Spokane Park Board Agenda

Oct. 12, 2017 – 1:30 p.m.

**CITY OF SPOKANE
PARKS AND RECREATION DEPARTMENT
CHANGE ORDER NO. 6**

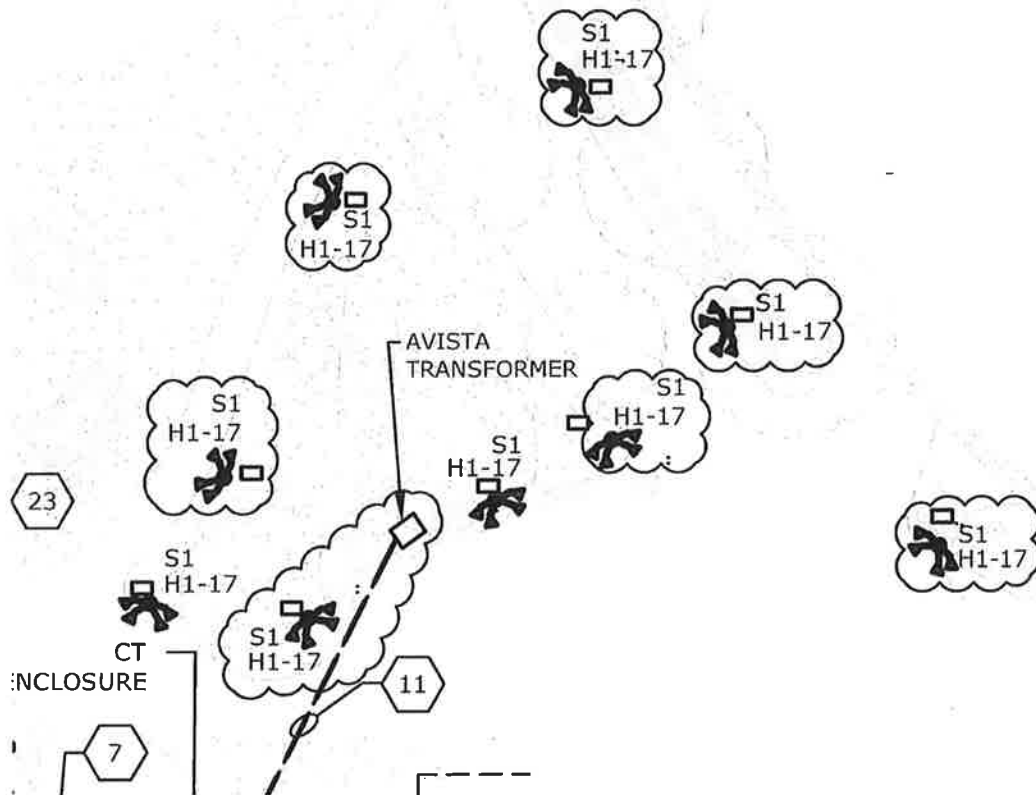
1. ZONE #25 - REPLACE BUBBLERS WITH SHRUB SPRAYS, AS SHOWN. REMOVE SLEEVING TO PRIOR-DESIGNED TREE GRATES. ZONE REDUCES TO 29.6 GPM. REPLACE 2" VALVE WITH 1.5" VALVE, AS SHOWN.

ES100

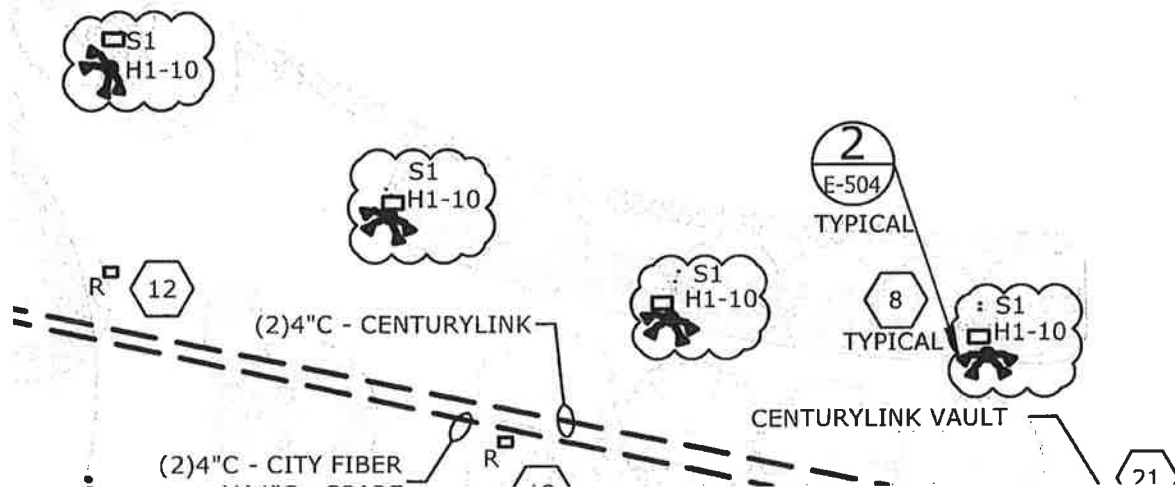
1. PROVIDE (2) ADDITIONAL TYPE S1 POLES FOR NEW PATHWAY AS SHOWN.
2. SHIFT TYPE S1 POLES TO FOLLOW PATHWAYS AS SHOWN.

Sheet No.
ASI12-11

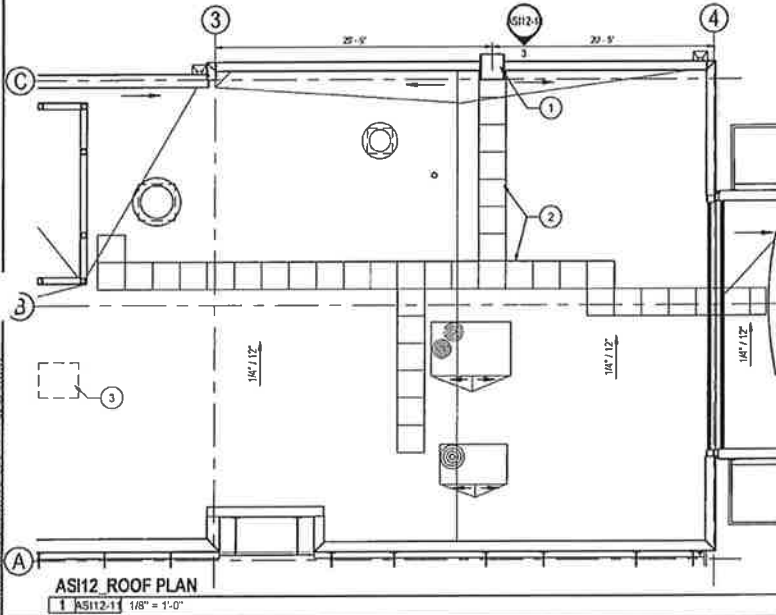
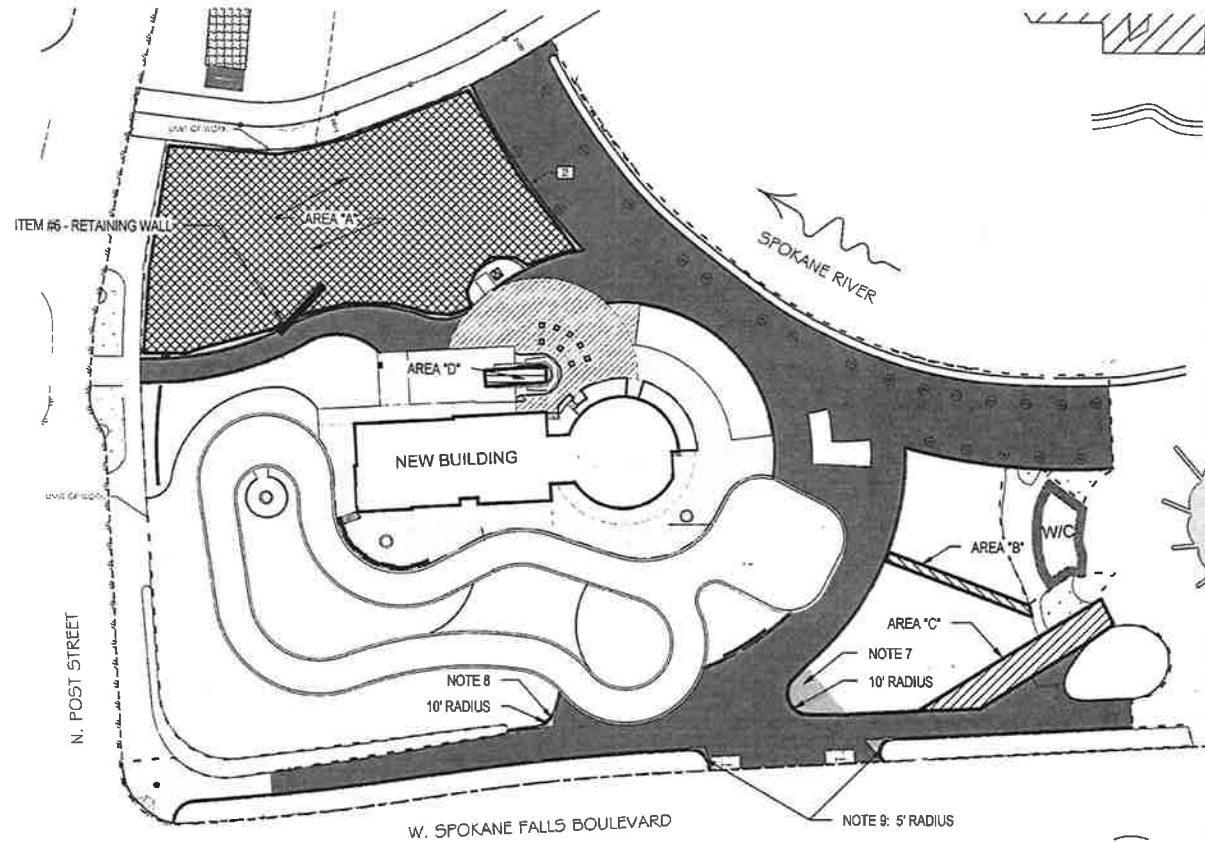
- 1 ADD EXTERIOR FIXED LADDER - GALVANIZED STEEL W/ STEEL MESH SECURITY DOOR - SEE DETAILS
- 2 ADD ROOF PADS FROM FIXED LADDER TO MECHANICAL LOCATIONS
- 3 REMOVE ROOF HATCH, RAILING AND LADDER

Title
PR3A - Addendum to PR-3

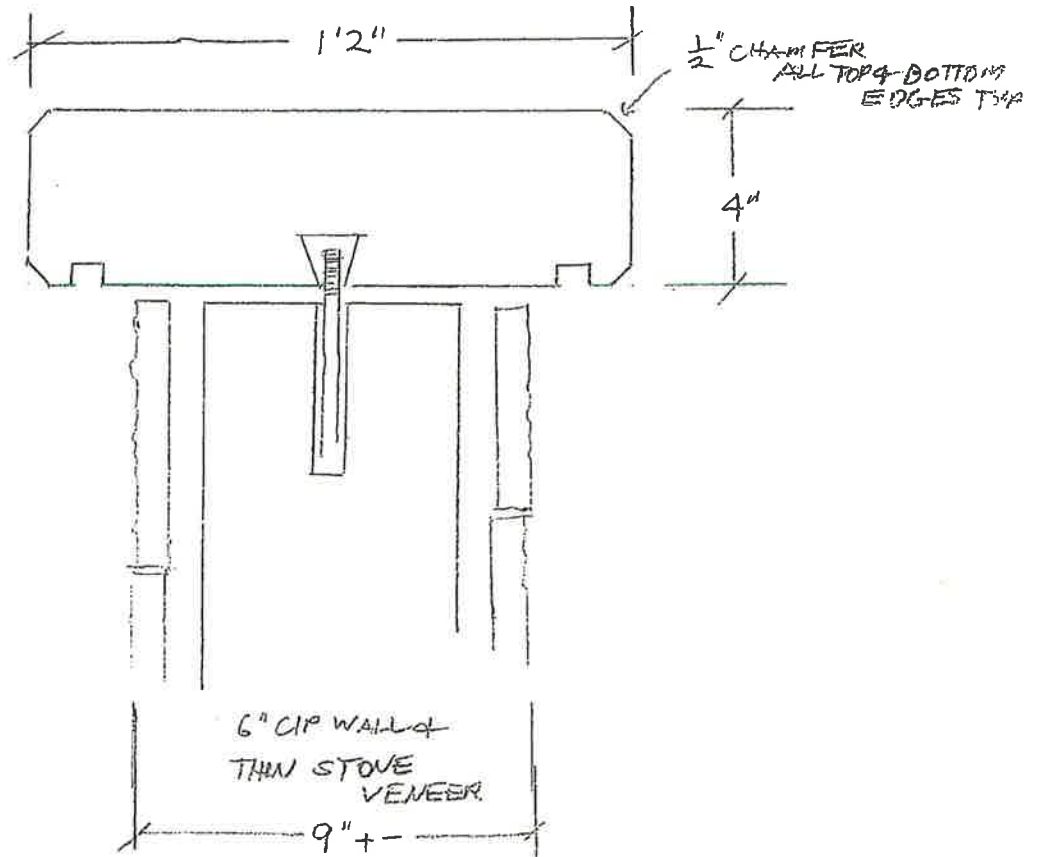
- 1) AREA A (NORTHWEST CORNER OF SITE):
A. CHANGE SOD TO HYDROSEEDING EXCEPT FOR SWALE.
- 2) AREA B (WEST OF FOUNTAIN CAFE):
A. DELETE INDICATED PATH.
- 3) AREA C (SOUTH OF FOUNTAIN CAFE):
A. CHANGE INDICATED PATH FROM CONCRETE TO ASPHALT
- 4) AREA D (UNDER SKYRIDE)
A. ELIMINATE SOD AND IRRIGATION (LEAVE STUB FOR FUTURE - RETAIN AT WEST END FOR REMAINING PLANTINGS) - REPLACE WITH MULCH PER PARK STANDARD.
- 5) GENERAL NOTE:
A. DELETE ALL ANNUAL PLANTS IN CONTRACT. NO REPLACEMENT.
- 6) ADD 12"± TO THE RETAINING WALL ON THE NORTH SIDE OF THE NEW WALKWAY (WALKWAY NOT SHOWN IN GRAPHIC). NOTE: GRAPHIC NOT TO SCALE, LOCATION SHOWN IS APPROXIMATE.
- 7) EXTEND GRASS AREA AND PROVIDE 10' RADIUS TO HARDSCAPE AT LOCATION INDICATED IN GRAPHIC.
- 8) PROVIDE 10' RADIUS TO HARDSCAPE AT LOCATION INDICATED IN GRAPHIC.
- 9) PROVIDE 5' RADIUS TO HARDSCAPE AT 2 LOCATIONS INDICATED IN GRAPHIC.

RIVERFRONT PARK -
REVISED BENCH SHAPE
% SPILTER PRECAST

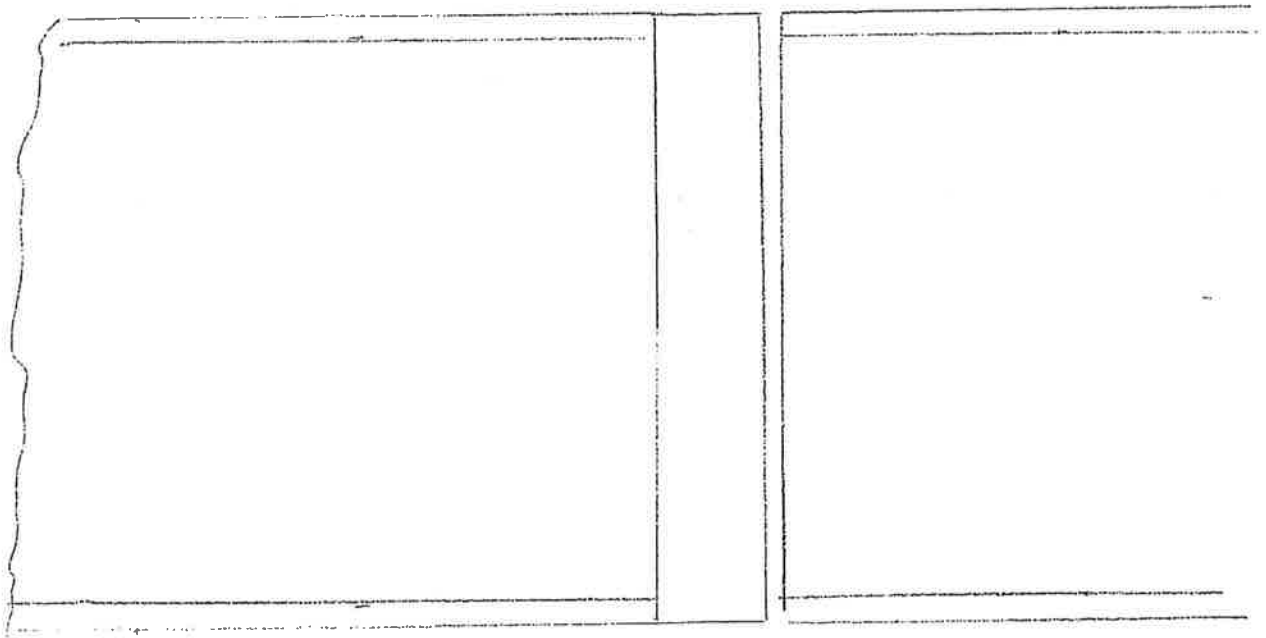
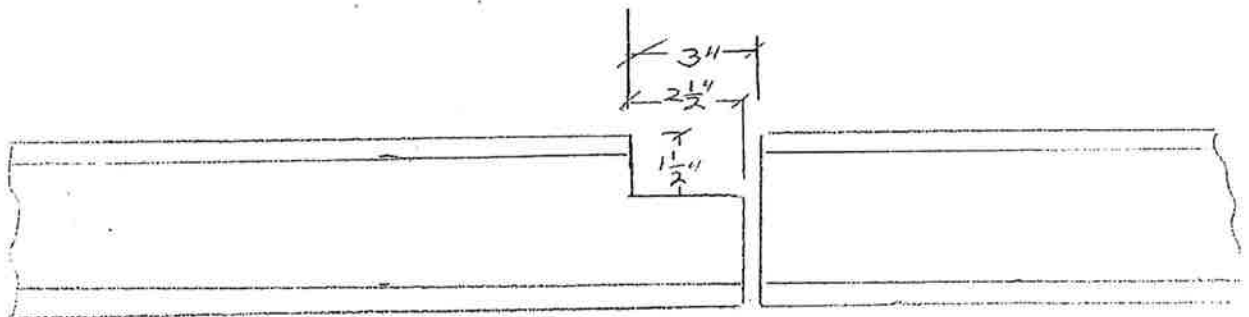
Attached is a breakdown of additional labor and material costs for natural stone veneer and the new precast cap final design. Pricing does not include staining or coloring of the precast caps. Once we receive a change order for this additional cost, we will place an order for the materials.

Structure ID: **Revised MH No. 1 (Design Change)**

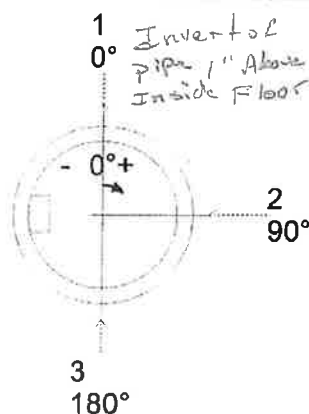
| Item Number | Description | Amount |
|------------------------|---|---------------------|
| ✓ PCO 35 | Change stormwater manhole #1 to avoid further rock excavation | \$956.22 ✓ |
